Accessibility Design Review Report

**Proposed Data Centre Development
1 Sirius Lane Cove West NSW 2066**

Prepared for:	AW Edwards
Job No:	78788
Date:	26th August 2019
Revision:	2
Phase:	DA Submission

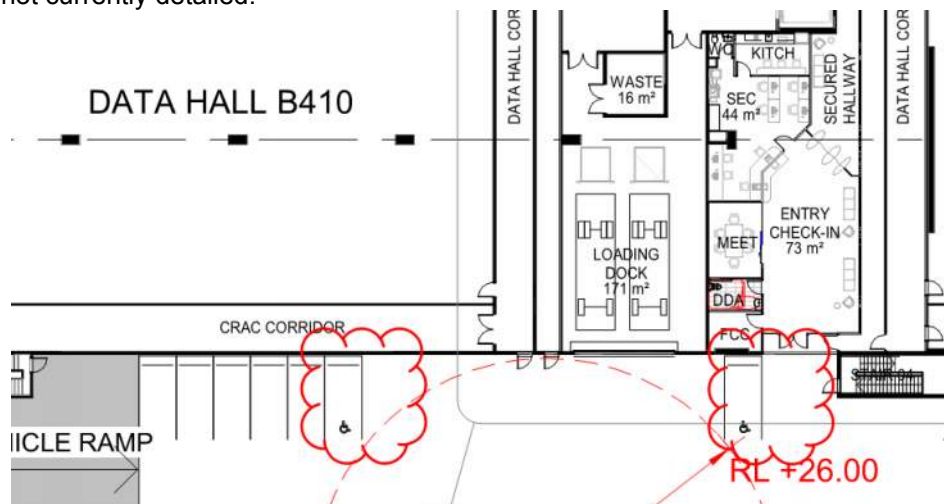
By virtue of the recognised level change from the boundary and lack of pedestrian access (illustrated in the below Google image extracts) it is considered that external access to the building will need to be addressed through a managed provision, with visitors to be made aware of the pedestrian access both outside of the boundary as well as from the boundary.

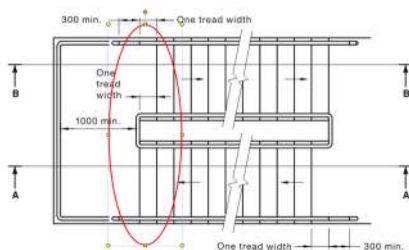
Circulation stairs and ramps will be required to be set-back from transverse paths of travel so that handrail extensions do not protrude into corridor paths of travel.

Offsetting the stair at the mid landing will allow a continuous single handrail which will not require vertical sections.
